Overview: Production error; immobilizer wire (orange/black) in pin position #4 instead of pin position #5. Although an effort to correct the issue was made, some quantity of harnesses did get shipped before the issue was spotted. We are advising to inspect the harness BLADE connector before attempting to install the harness and program the module.

Overview: The FTI-STP1 harness may require modification for use in **automatic transmission (AT)** applications, some of the product was able to be modified before release, but a small quantity was released before being able to be modified internally.

FTI-STP1: Vehicle Coverage and Preparation Notes

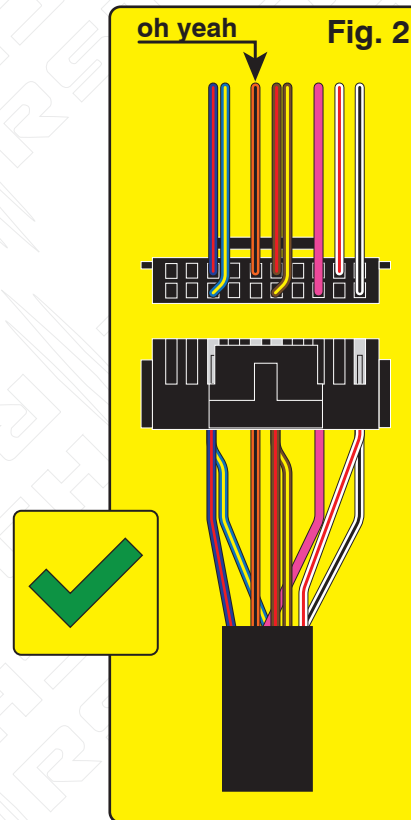
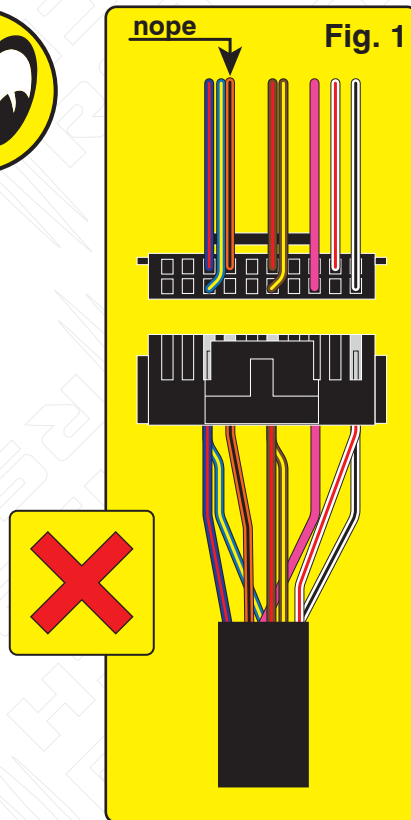
Issue: Module fails to program to vehicle, will not allow the vehicle to be remote started.

Correction: Step 1.) Locate the orange/black wire and confirm whether it is positioned as illustrated in Fig. 1 or Fig. 2. If the wire is as illustrated in Fig.1, proceed with Step 2 through 5 and complete the repair procedure outlined, if the wire is as illustrated in Fig. 2, correction is not necessary, proceed with harness installation and module programming.

Step 2.) Using a pick, lightly depress the catch that secures the terminal in the housing then remove the wire and terminal from the housing.

Step 3.) Using a fine tip razor or utility knife, insert the blade beneath the terminal catch and raise it slightly, so that it can be reused to secure the terminal when reinserted into the BLADE connector housing.

Step 4.) Refer to Fig. 2 for correct position of the orange/black wire (next to brown/red) then reinsert the terminal, pressing lightly until the catch 'snaps' into place, securing the terminal in the connector housing.

Step 5.) The repair is complete, proceed with installation and programming.

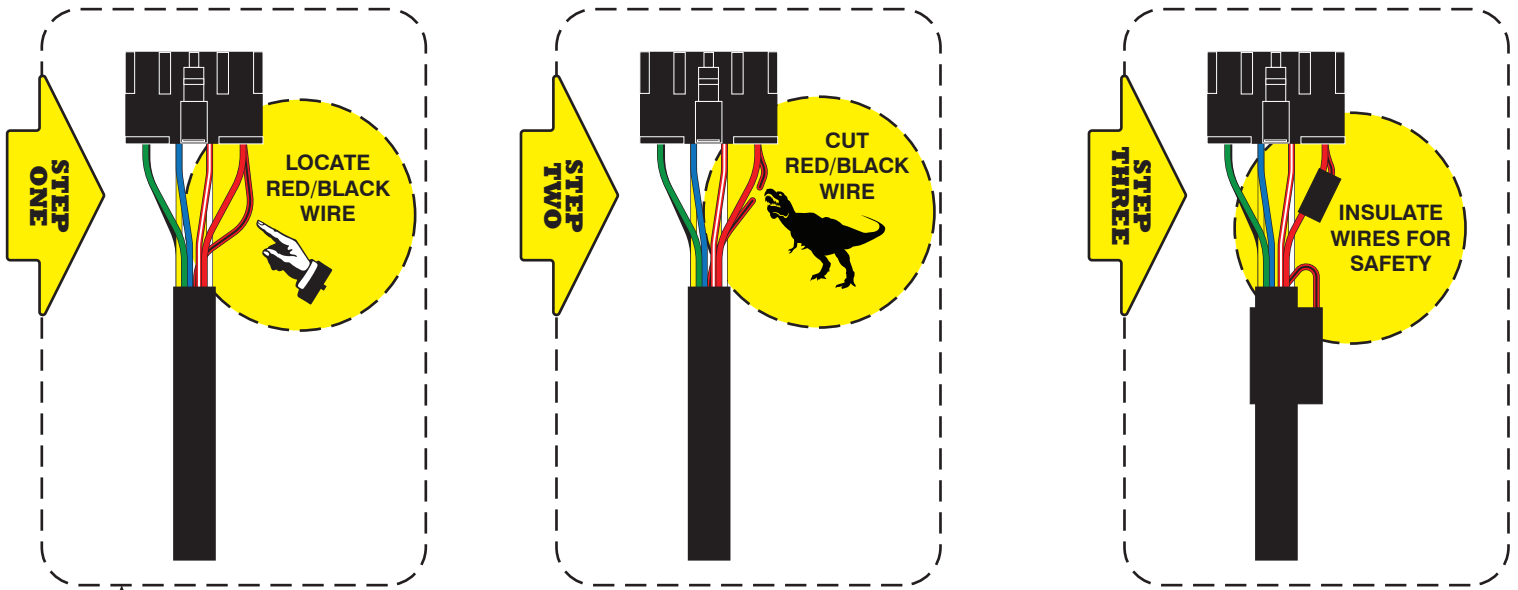
Issue: The FTI-STP1 T-harness has been designed to be compatible with AT (automatic transmission) & MT (manual transmission) applications, but due to a production oversight, the selection mechanism was defaulted to MT mode.

Using a harness configured for an MT application, in an AT equipped vehicle, could result in vehicle module damage, it is advised that the harness be returned to AT mode before installation in vehicles equipped with an automatic transmission.

Correction: Locate the **red/black (+ Clutch)** wire provided in the CN1 connector of the main harness assembly. Cut the **red/black** wire, either flush to the CN1 connector, or leaving enough wire exposed so that you can insulate and secure the ends of the wire that remain after cutting. Insulate each of the remaining ends of the **red/black** wire and secure to prevent any possibility of a short circuit.

If the red/black wire already been disconnected, no further modification is required for AT equipped vehicles.
